CERTIFICATE OF APPROPRIATENESS PLACARD

708 DOROTHEA DRIVE

188-14-MW

Raleigh Historic Development Commission – Certificate of Appropriateness (COA) Application

708 DOROTHEA DR.

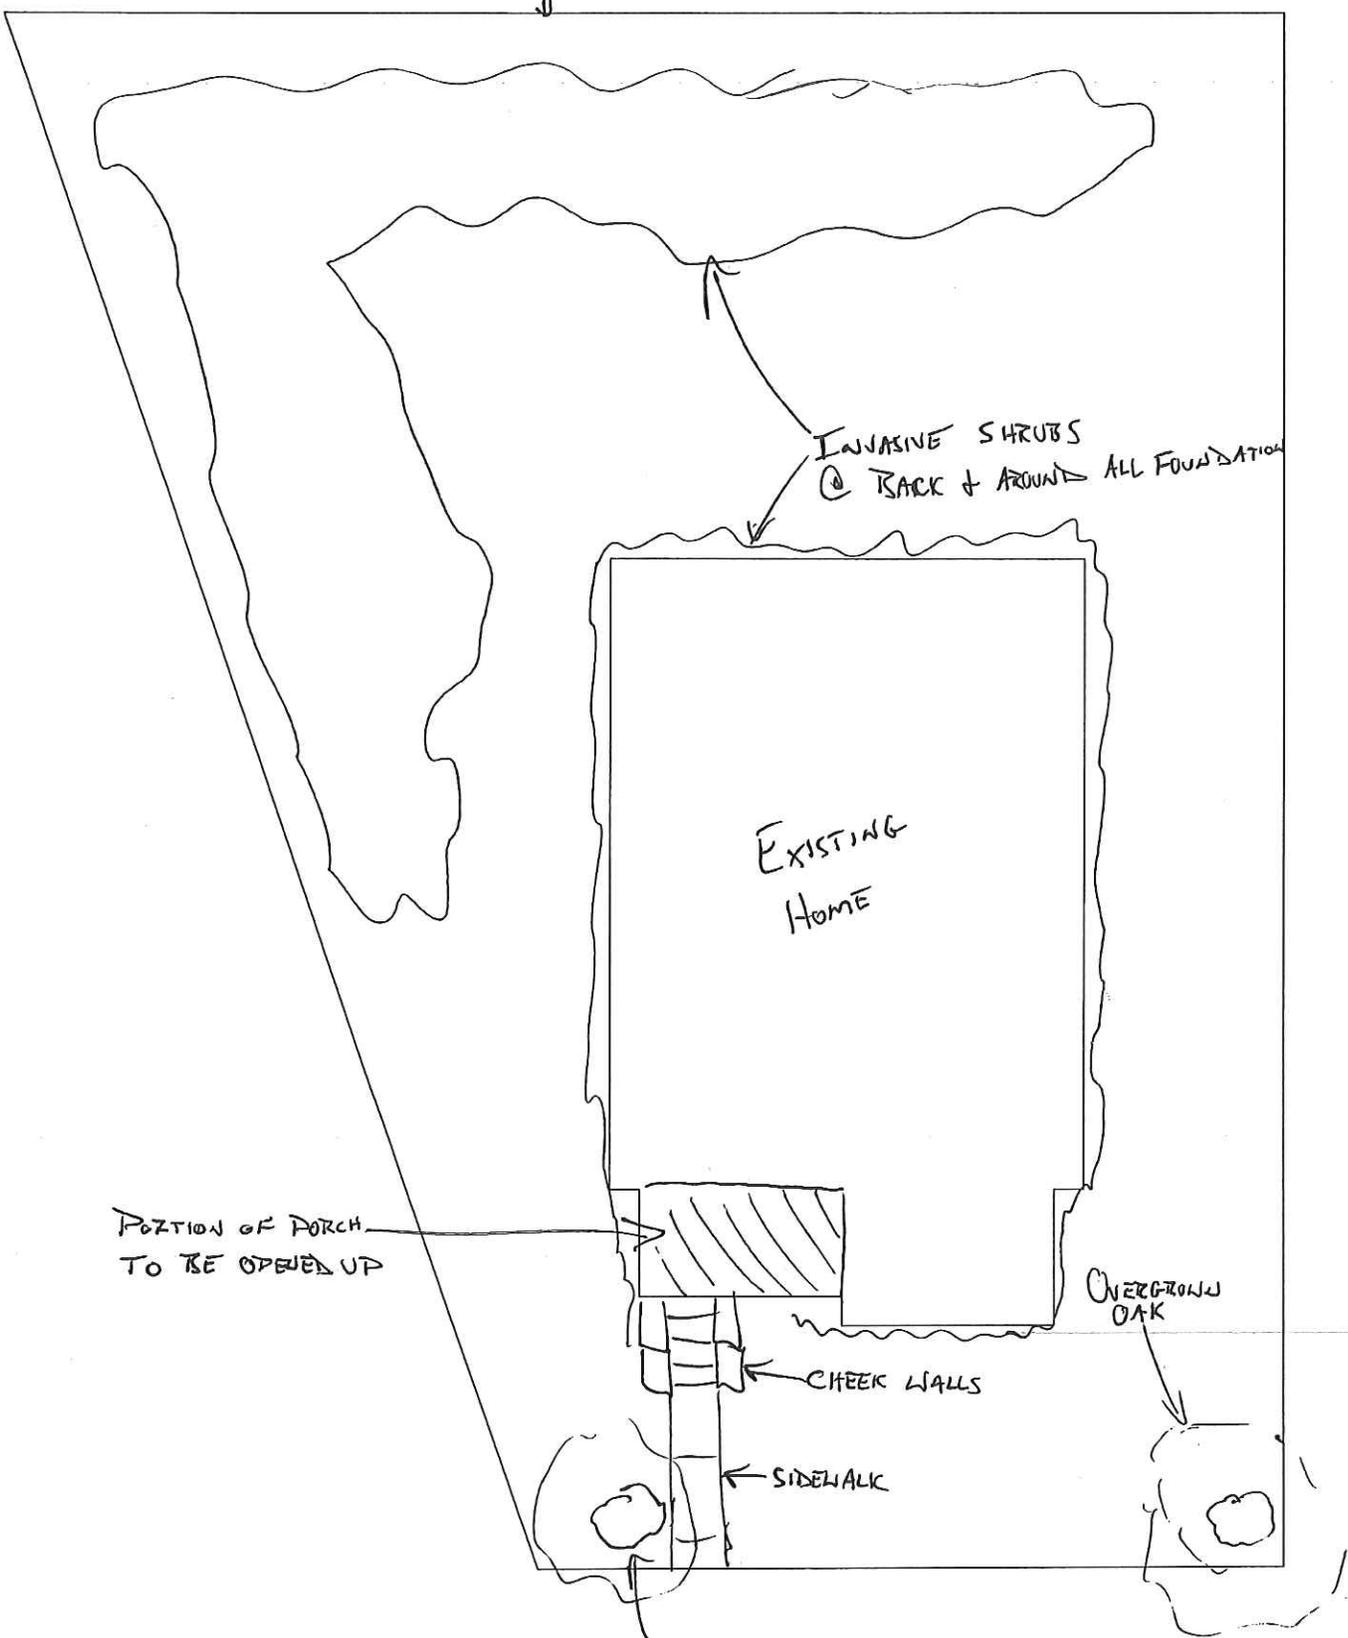
Work items not in this COA and not yet approved. TGT 12/8/14

replacement
Must be handled in a separate COA. TGT 12/8/14

Need arborist report to OK this.

- Repair of front walk: Before removal of the roots can be approved you will need an assessment by an arborist to ensure that the tree will remain healthy and structurally sound. To avoid delay of approval of this entire application I suggest that you amend the application to simply replace the concrete sidewalk going around the tree roots. **Let's remove this for now since it's not pertinent to renovations at this point. I'll make sure to submit the correct documentation in the future.**

removed from app per 12/12/14 email. TGT
